ALERT SERVICE BULLETIN
REVISION NOTICE

**SUBJECT: REVISION "A" TO ALERT SERVICE BULLETIN 205-09-102:
TAIL ROTOR BLADE P/N 212-010-750-ALL, INSPECTION OF.**

Revision "A" of this bulletin incorporates changes to the compliance date and warranty period and clarifies the compliance requirements depending on blade part number, aircraft model and configuration.

Figure 1

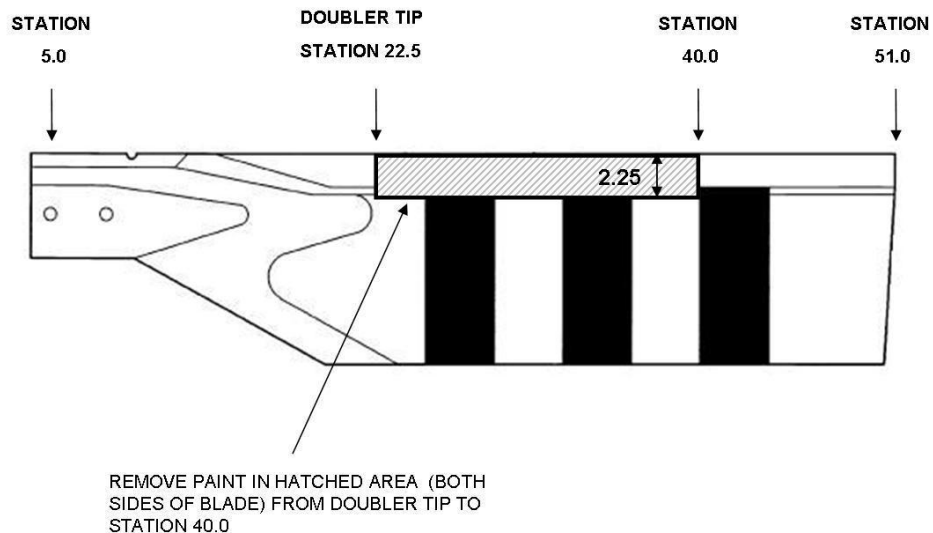
4. Ensure that all paint (on the spar only) is removed from the first 2.25 inches of the leading edge (chordwise) and from the B.S 22.5 (doubler tip) to B.S. 40.0. Refer to Figure 1. This will expose the spar up to the fillet between the blade spar and skin. A fillet filled with adhesive runs spanwise between the blade spar and the skin 2.25 inches aft of the blade leading edge, both inboard and outboard sides. The area to be inspected runs along the edge of the spar fillet and a half inch forward of this point. (Between 1.75 and 2.25 inch from the leading edge of the blade and from Blade Stations 22.5 to 40.0, both inboard and outboard sides).

5. Wipe area with a clean cloth dampened with alcohol (C-385) or aliphatic naphtha (C-305) and dry thoroughly.
6. Carry out a detailed visual inspection of the spar for corrosion and/or pitting using a 3-power or higher magnifying glass. Anomalies on the steel spar 0.003 inch deep or less must be polished out in accordance with BHT-205A1-MM.

Any defect greater than 0.003 inch deep is cause for rejection and the blade must be removed from service.
